REGULAR OPEN MEETING OF THIRD LAGUNA WOODS MUTUAL ARCHITECTURAL AND CONTROL STANDARDS COMMITTEE

Monday November 22, 2021: 9:30AM - 11:30AM VIRTUAL/IN PERSON MEETING

NOTICE and AGENDA

WATER HEATER STORAGE CABINET

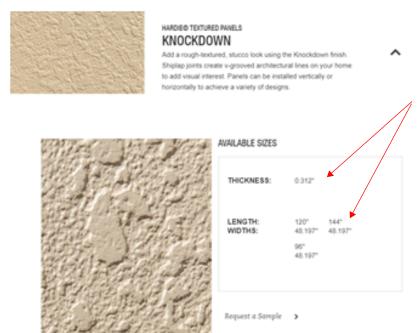
Typically it is preferred to have a 4" concr. slab of 2,000 psi conc., w/ 8X8 W.W.F., and an 8" deep by 12" wide perimeter footing. Slab over 4" sand or agregate base material on 24" compacted sub-grade.

Details do not show access door, hardware, or conc. pad alternative. this should be provided w/ dtl.

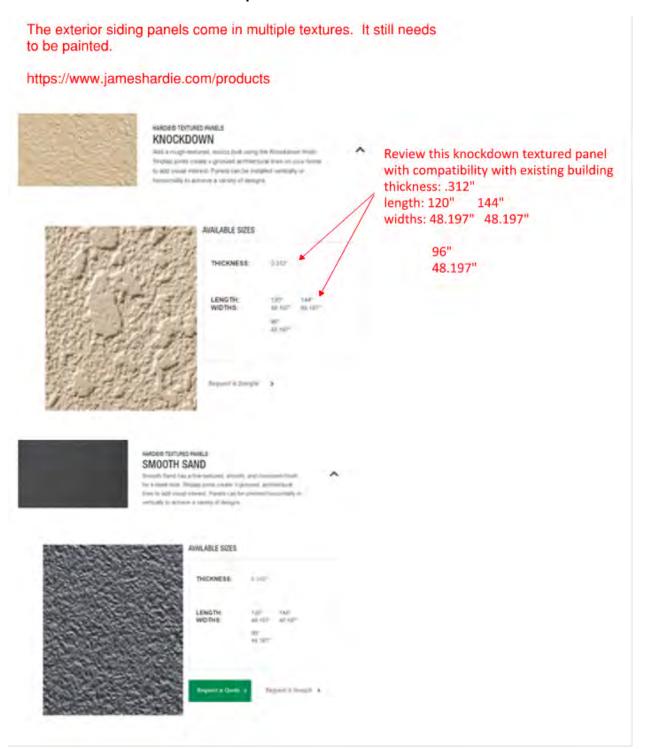
No reference to if the enclosure is to be locked and who is allowed access.
